## 2.0 SITE CHARACTERISTICS

### 2.5.4 Stability of Subsurface Materials and Foundations

The Tennessee Valley Authority (TVA) Early Site Permit (ESP) Site Safety Analysis Report (SSAR), Revision 1 (TVA, 2017 - Agencywide Documents Access and Management System (ADAMS) Accession No. ML18003A374), Section 2.5.4, "Stability of Subsurface Materials and Foundations," presents an evaluation of the stability of subsurface materials and foundations that relate to the Clinch River Nuclear (CRN) Site. The properties and stability of the soil and rock underlying the site are important to the safe design and siting of the plant. The information provided by the applicant in SSAR Section 2.5.4 addresses: (1) Geologic features in the site vicinity; (2) static and dynamic engineering properties of soil and rock strata underlying the site; (3) the relationship of the foundations for safety-related facilities and the engineering properties of underlying materials; (4) results of geophysical surveys, including in-hole and cross-hole explorations; (5) safety-related excavation and backfill plans and engineered earthwork analysis and criteria; (6) groundwater conditions and piezometric pressure in all

**Figure 2.5.4-1: Geotechnical Cross-Section of the Stratigraphy of the Power Block Area (Reproduced from SSAR Figure 2.5.4-2)**

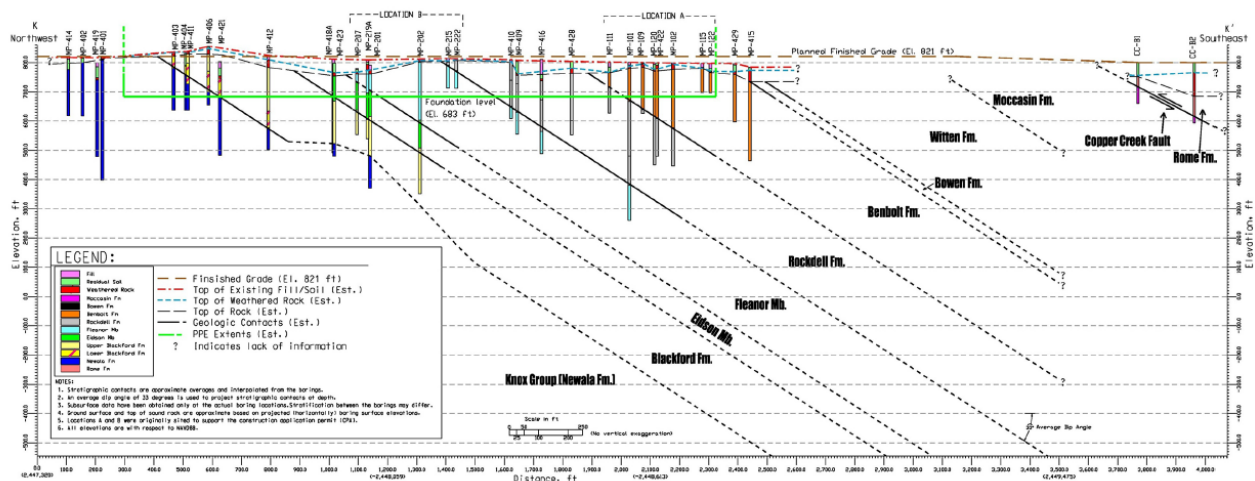
The staff reviewed the subsurface profiles and materials described in SSAR sections 2.5.4.2.1.3 through 2.5.4.2.1.11. The staff reviewed SSAR Figure 2.5.4-2, which shows the bedrock structure and succession of the stratigraphic units underneath the power block area. The stratigraphic units encountered at the site include: Benbolt Formation, Rockdell Formation, Fleanor Member (Lincolnshire Formation), Eidson Member (Lincolnshire Formation), Blackford Formation and Newala Formation. SER Table 2.5.4-1, summarizes the characteristics and properties of these formations. The staff focused its review on the Benbolt Formation and the Fleanor Member of the Lincolnshire Formation, which are the stratigraphic units on which the power block of the nuclear power plant is expected to be founded. The applicant described the Benbolt Formation as a gray limestone that is strong, very thinly bedded and locally moderately bedded. The applicant also described the Benbolt Formation as a nodular limestone with little to some laminated to thinly bedded calcareous siltstone. The staff noted that the average vertical thickness of the formation is approximately 100.6 m (330 ft) and that the RQD averages 88 percent, which is indicative of a good quality rock. The applicant described the Fleanor Member as a red bedrock that is medium strong, to strongly laminated, to medium bedded calcareous siltstone with few to little gray micritic limestone layers. The staff noted that the average vertical thickness of the formation is approximately 78.3 m (257 ft) and that the RQD averages 89 percent, which is indicative of a good quality rock. The staff noted that the applicant used standard industry methods and techniques to describe the stratigraphic units at the site. The staff reviewed boring logs, field notes, and photographs to verify the applicant's descriptions of the stratigraphic units at the site. Based on its review of the information provided, the staff determines that the applicant appropriately described the stratigraphic units at the CRN Site.

The applicant chose two specific locations, Location A and Location B, as candidates of power block location that are illustrated in Figure 2.5.4-1. This non-unique power block area selection was based on the dipping strata at the CRN Site that results in the presence of varying stratigraphic units beneath the potential power block area, and the possibility that multiple reactor units will be built at the site.

The staff reviewed the cross-sections provided in SSAR Figures 2.5.4-2 and 2.5.4-12 in detail, and the results of all subsurface investigations conducted at the CRN Site. The staff finds that the applicant conducted sufficient site investigations and provided adequate descriptions of the subsurface material conditions for the ESP application.

**Figure 2.5.4-5: Base case Shear Wave Velocity Profiles for Location A (Reproduced from SSAR Figure 2.5.4-20)**

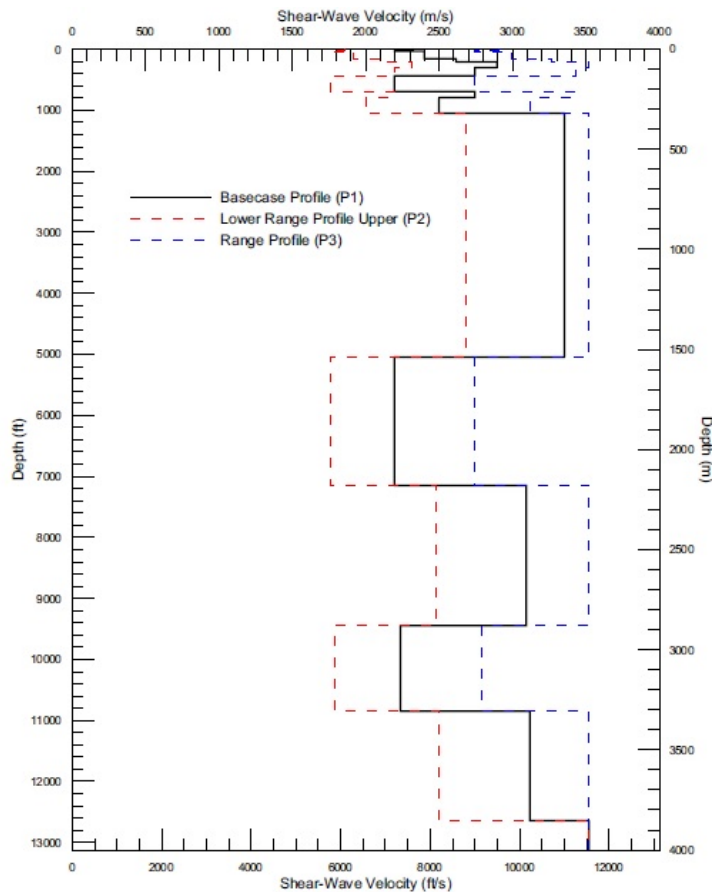
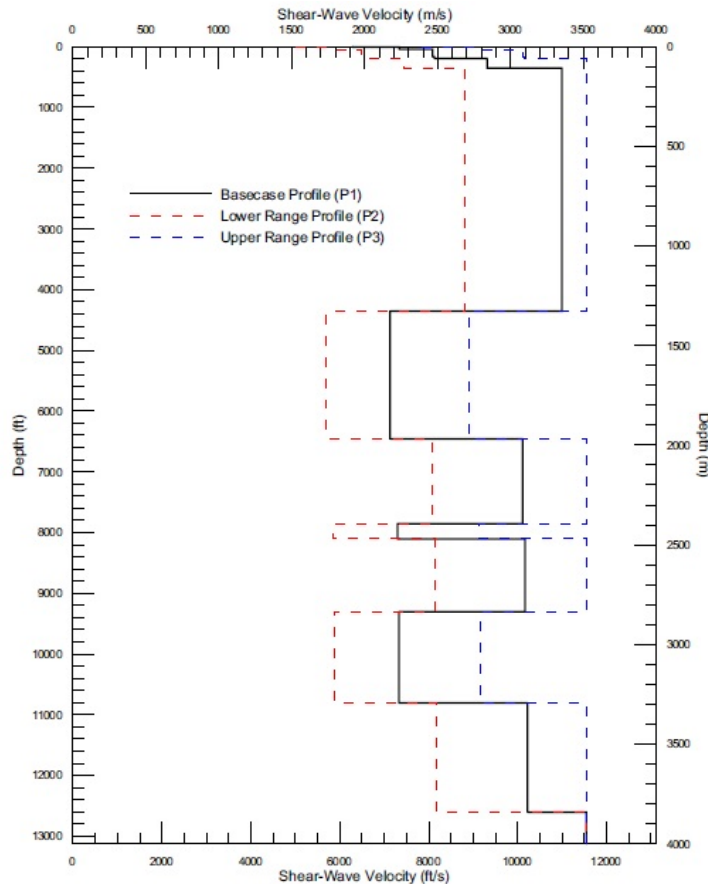
The staff examined the results of the applicant's geophysical surveys and paid special attention to the  $V_s$  and  $V_p$  profiles. The staff reviewed SSAR Figures 2.5.4-5 and 2.5.4-6, which show the  $V_s$  and  $V_p$  profiles developed from the downhole geophysical testing and suspension velocity logging for each of the stratigraphic units. The staff also reviewed SSAR Figure 2.5.4-7, which shows the seismic tomography models for the CRN Site. The staff noted that the applicant conducted a series of geophysical surveys using different methods that provide sufficient and reliable data to determine the in situ dynamic properties of soil and rock at the CRN Site.
